DEPARTMENT OF  
**Planning &  
Development**

## STAFF BRIEF

**Project:** Woodward Apartments

**Address:** 10101 WOODWARD

LANDSCAPE PLAN  
SCALE: 1"=20'

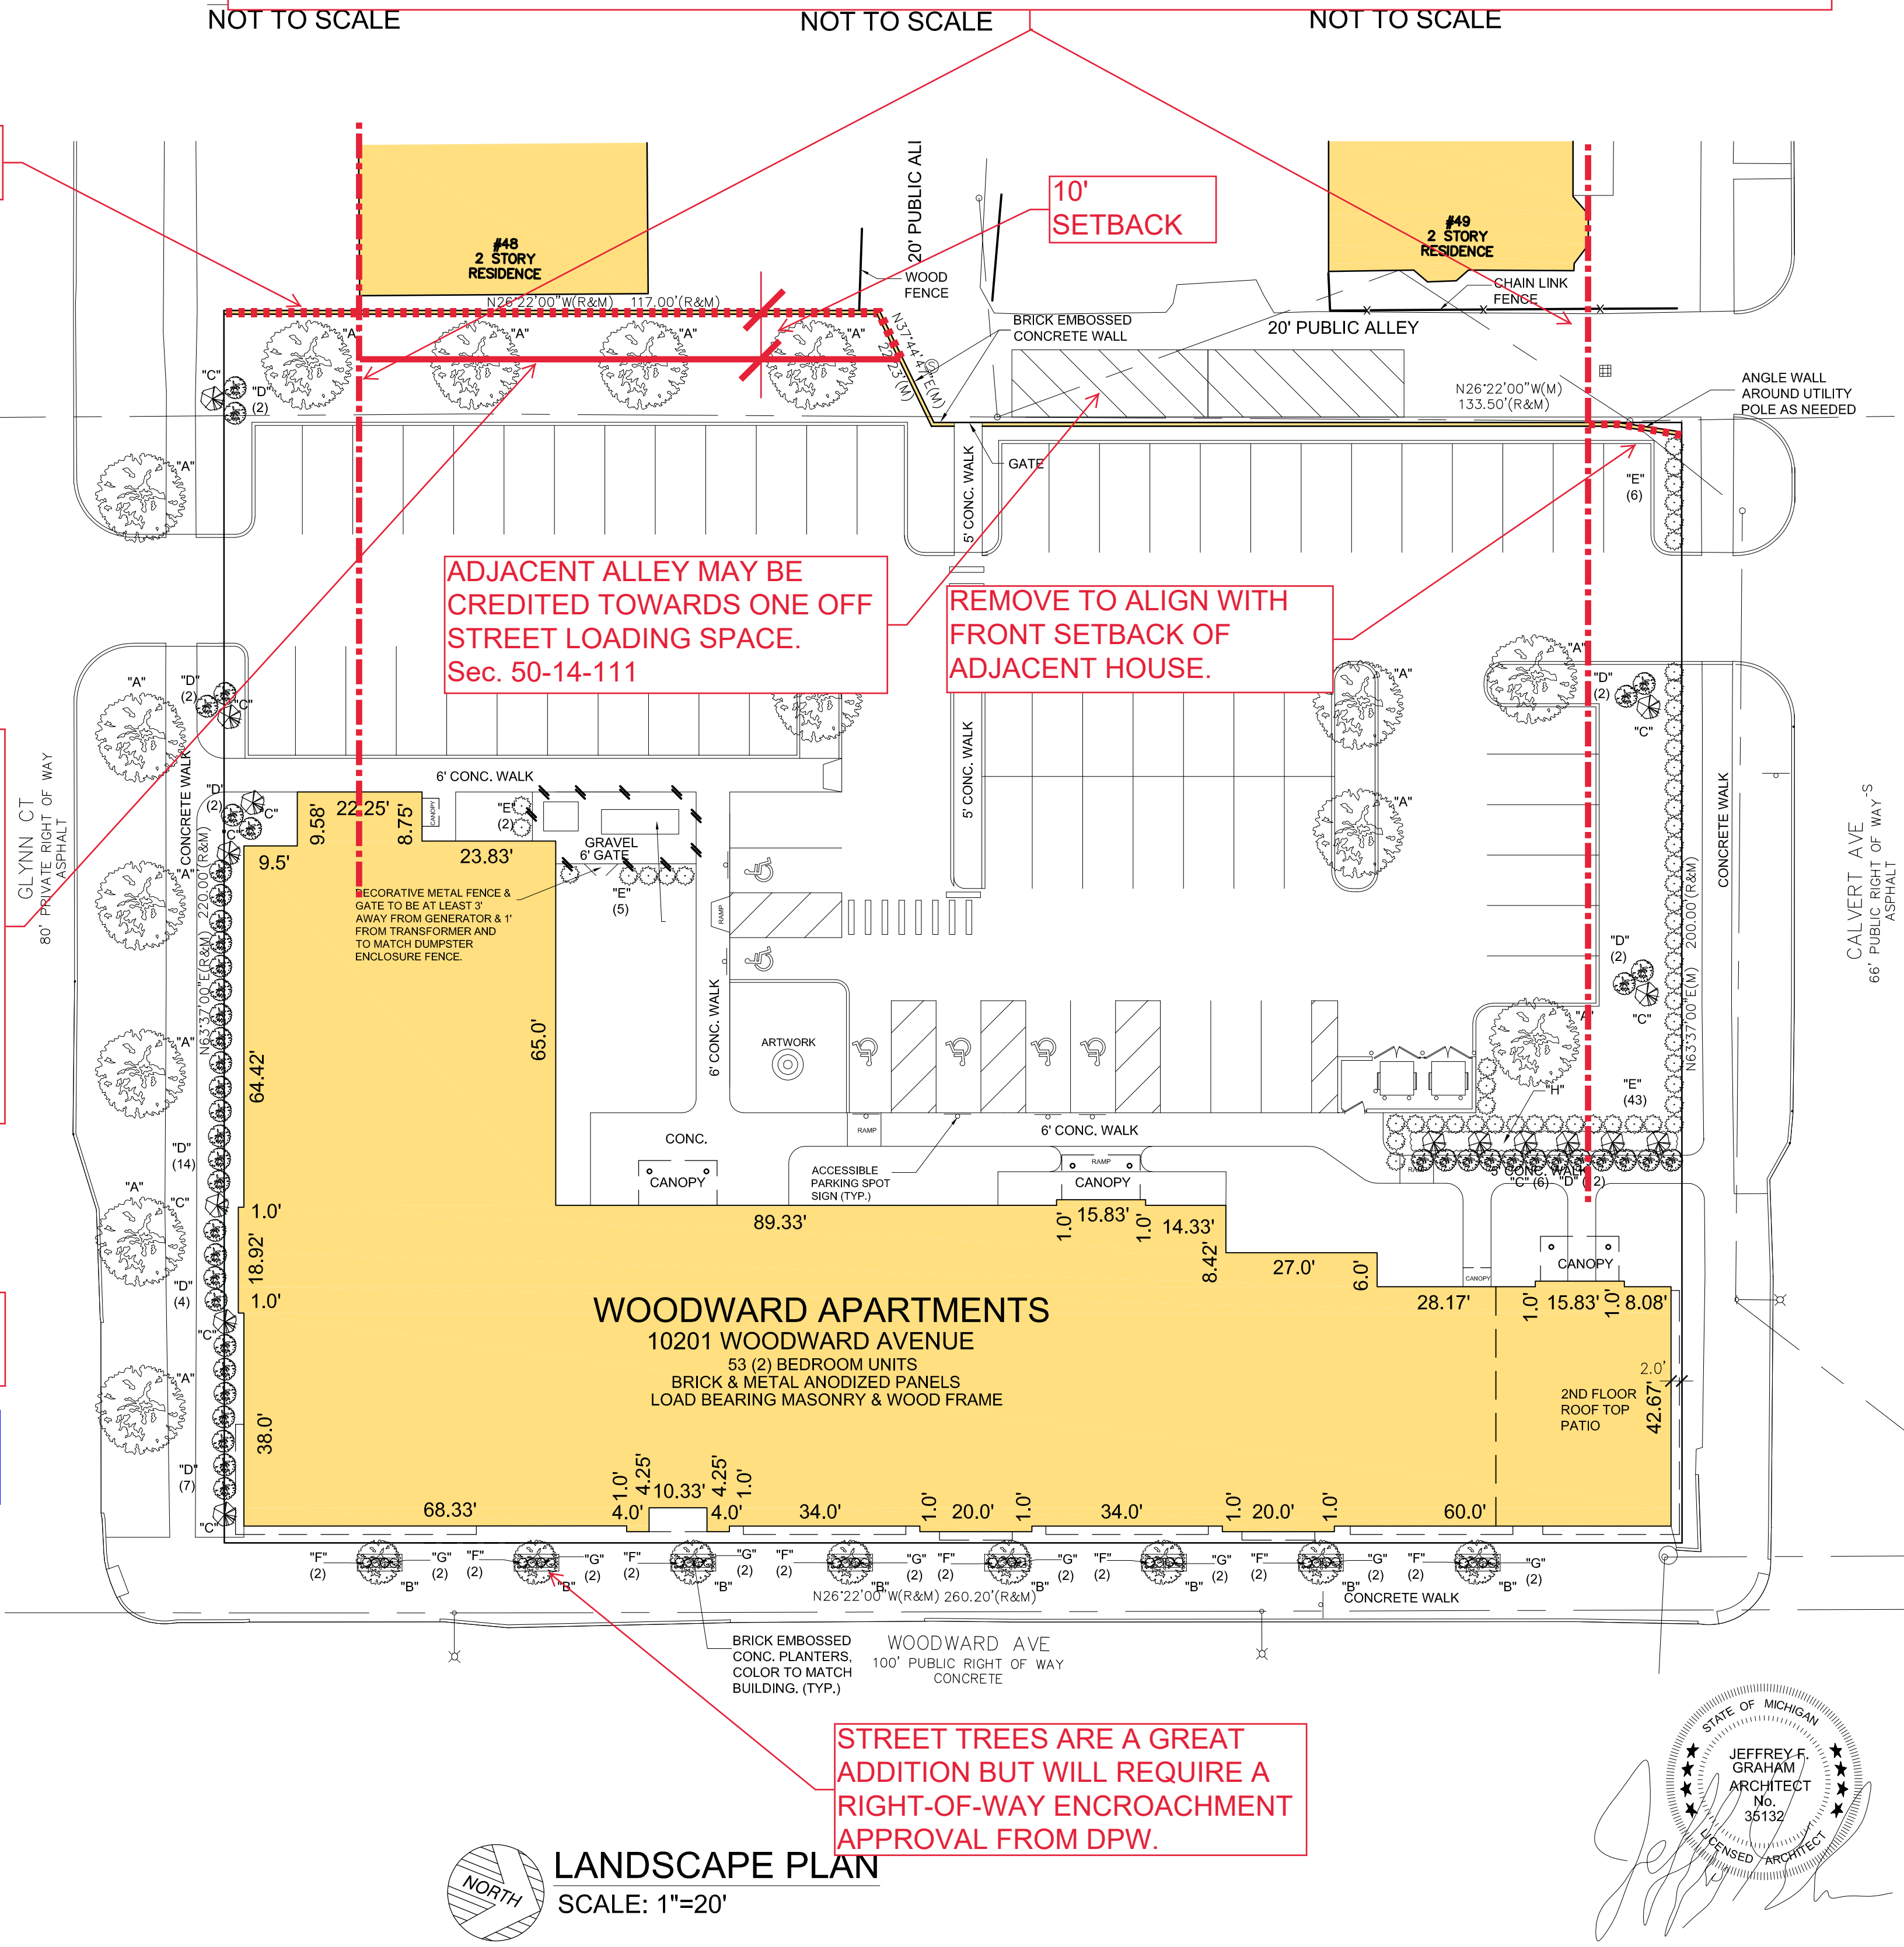
PROVIDE REQUIRED RESIDENTIAL SCREENING:

Sec. 50-14-342. - Residential screening.

(1)Abutting Residentially-zoned lots containing dwelling units.a.Where a zoning lot that has a dwelling unit on land zoned R1, R2, R3, R4, R5, R6, or residential PD and abuts, or is located across an alley or public street not exceeding 60 feet in width from, a parking area visible from the residential lot, an opaque wall shall be placed at the edge of the parking area to screen the parking area. Opaque screening, such as the following, is acceptable:1.A brick wall;2.A masonry wall with brick facing;3.A masonry wall with decorative metal fence topping;4.A concrete wall with brick design;5.A stone wall; or6.Other opaque wall which, in the determination of the Planning and Development Department, is both suitable for the site and compatible with, and similar to, the building frontages nearest the parking area.b.The nearest parking space, drive aisle, or other paved surface within the parking area shall be located at least ten feet from the abutting residential lot. Said setback area shall be landscaped. (See Figure 50-14-342.)

PARKING SPACES SHOULD ALIGN WITH ADJACENT RESIDENTIAL SETBACK.

Sec. 50-14-223. - Layout and setback.

(b)Front setback. Where the side zoning lot line of a parking area is contiguous to, or across an alley from, land that is zoned R1, R2, R3, R4, R5, R6, or residential PD, a front setback equal to the front yard of the abutting lot shall be provided, except in those instances where residential structures have been erected on the rear one-half of the zoning lot. In such instances, and in those cases where the abutting lot or parcel is vacant, a front setback of 20 feet in depth shall be provided.
